## ADDENDUM

**ADDENDUM NO.:** 03  
**PROJECT NAME:** CIP Central Hearing Facility Roof and MEP Upgrades  
**PROJECT NO.:** 04044  
**CONTRACT NO.:** C1606  
**DATE OF ISSUE:** December 29, 2023

### NOTICE OF CHANGES, MODIFICATIONS, OR CLARIFICATIONS TO CONTRACT DOCUMENTS

2 FOURTH & SIXTH FLOOR ROOF CONSTRUCTION PLANS  
SCALE: 1/8"=1'-0"

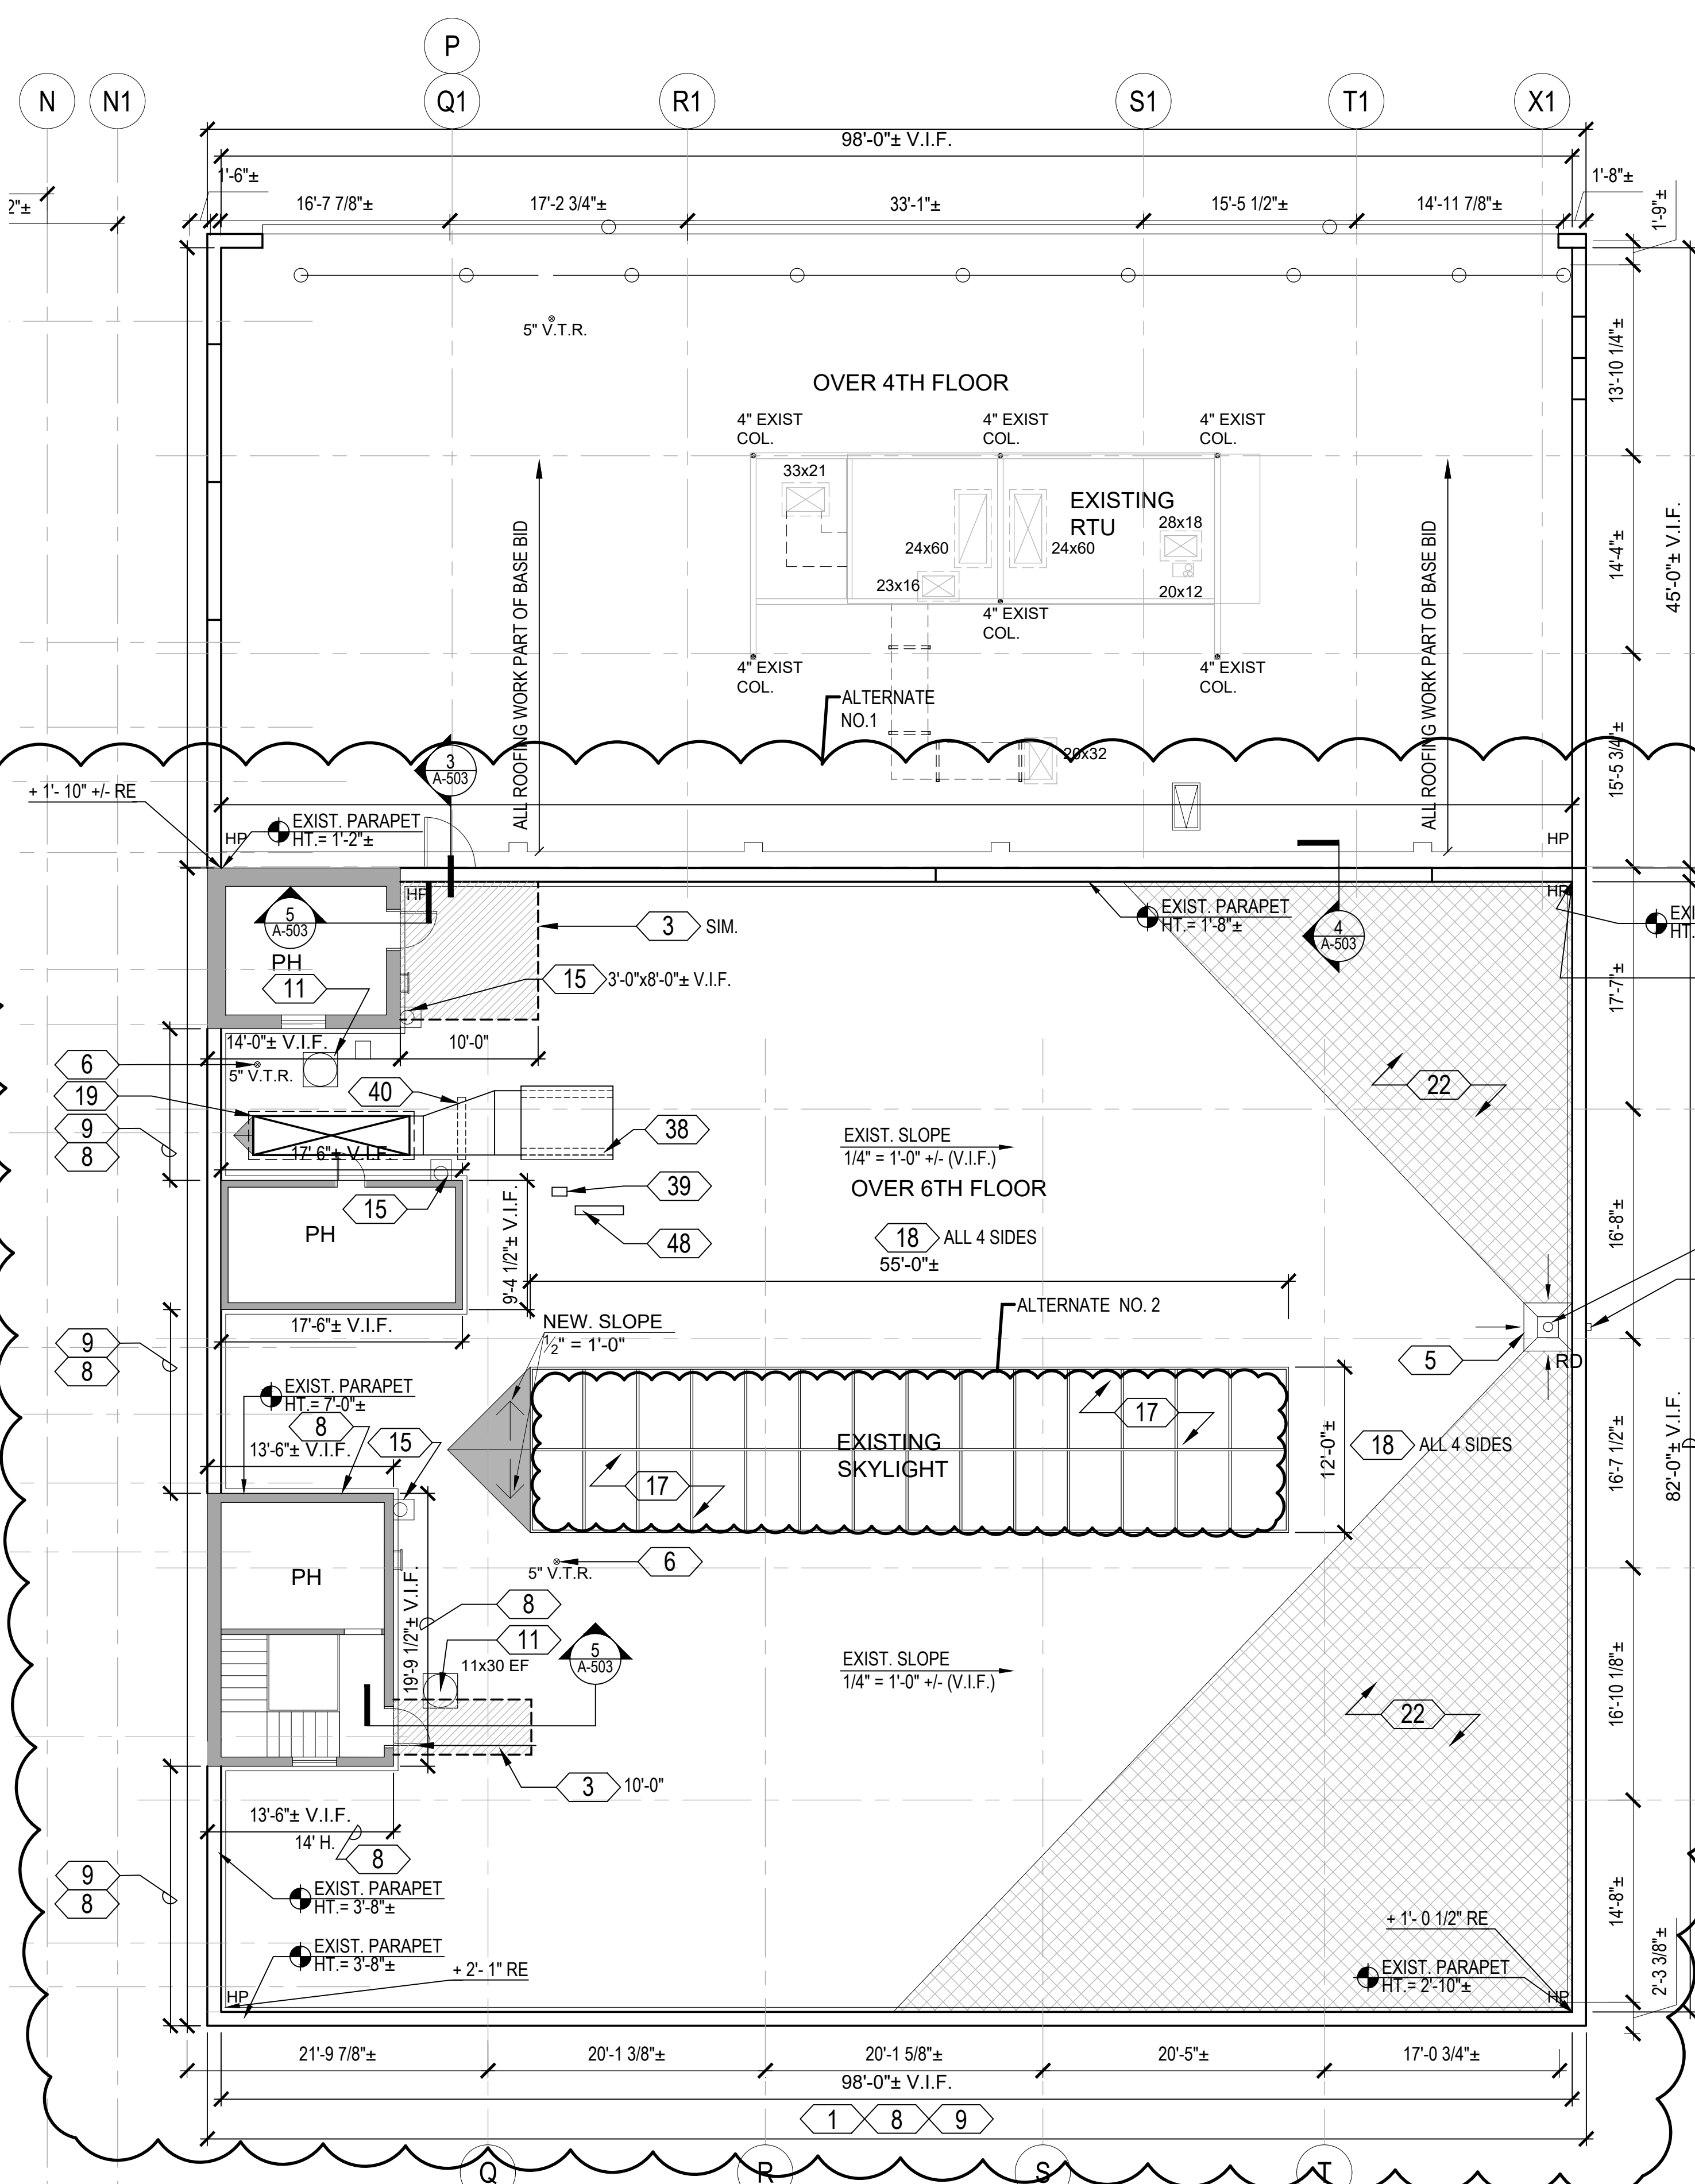
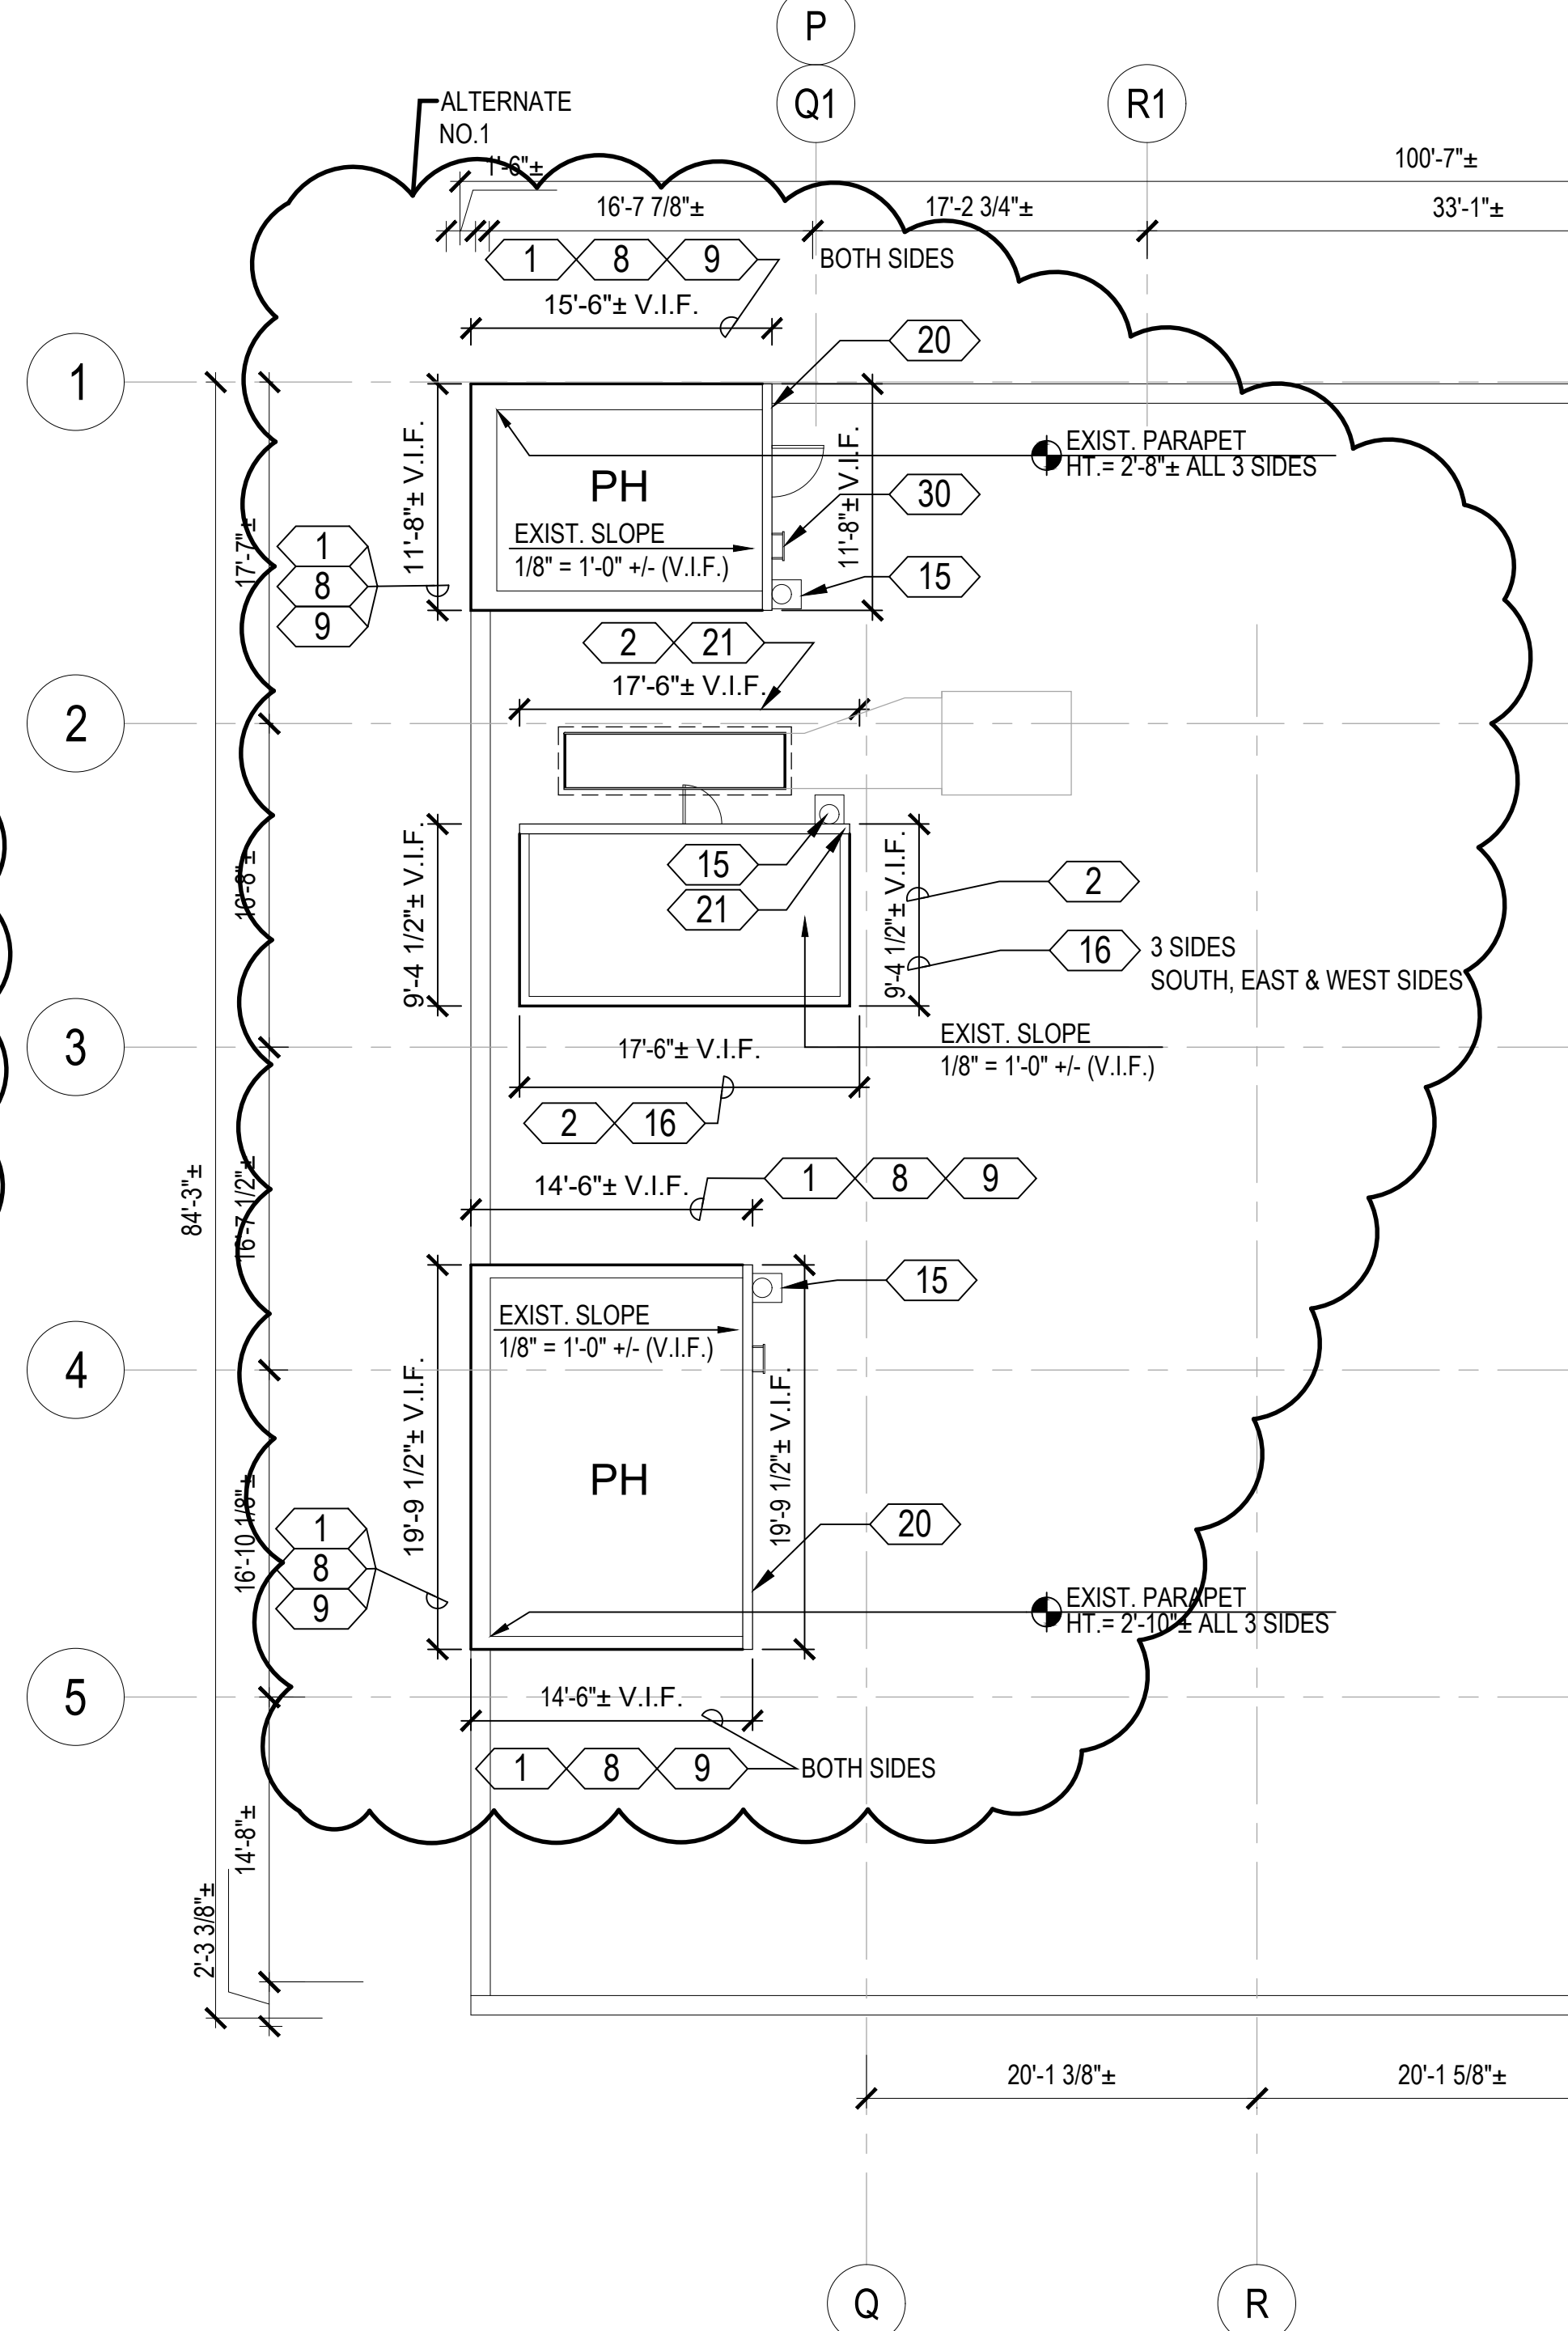
**Change 7** Drawing No. AR-101 – **REVISED** Key Notes 11, 39 and 47, dated 12.29.23  
**Change 8** Drawing No. AR-102 – **REVISED** Key Notes 11, 39 and 47; & one detail target, dated 12.29.23

**Change 9** Drawing No. AR-102A – **REVISED** Key Notes 11, 39 and 47, dated 12.29.23  
**Change 10** Drawing No. P-000 – **REVISED** sheet to add Plumbing Piping Materials, dated 12.29.23

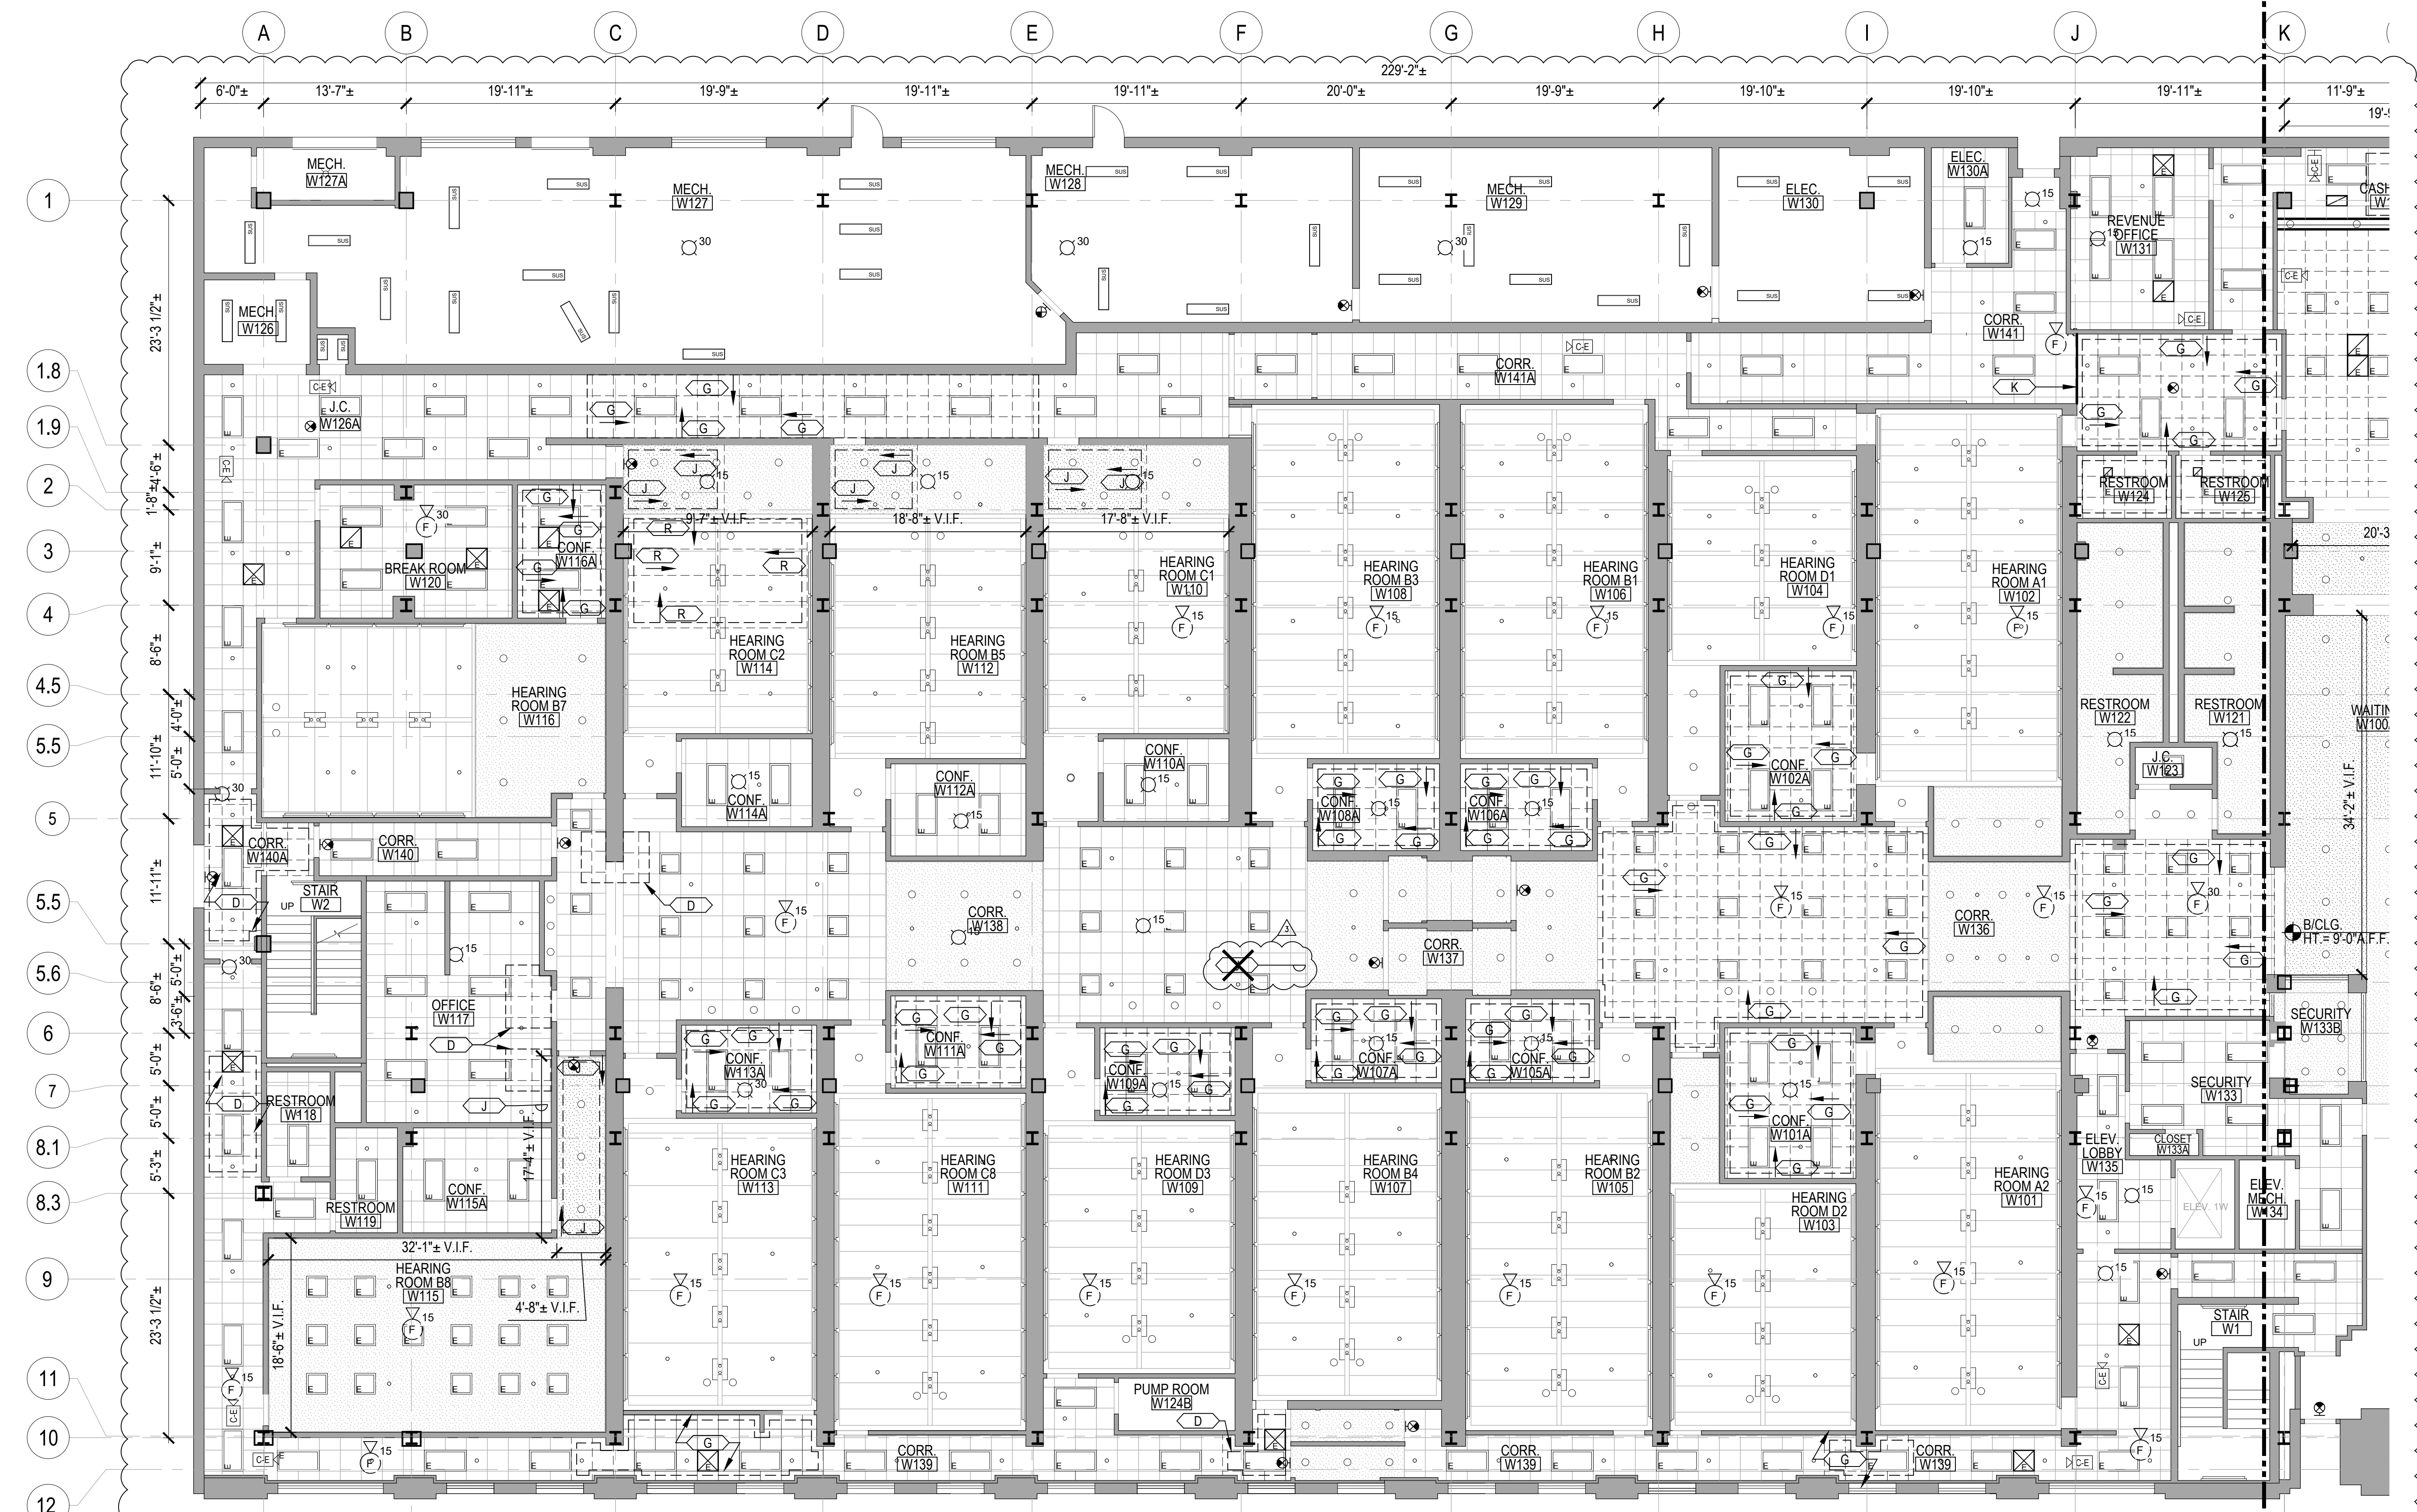
**Question:** On sheet ACD-101W there is a KN letter J at Corridor #W137. Please advise if this keynote is for the entire gypsum board ceiling area or a portion thereof, as there are no hatch lines indicating the extent.

**Response:** Keynote J on sheet ACD-101W has been revised and is included in this Addendum.
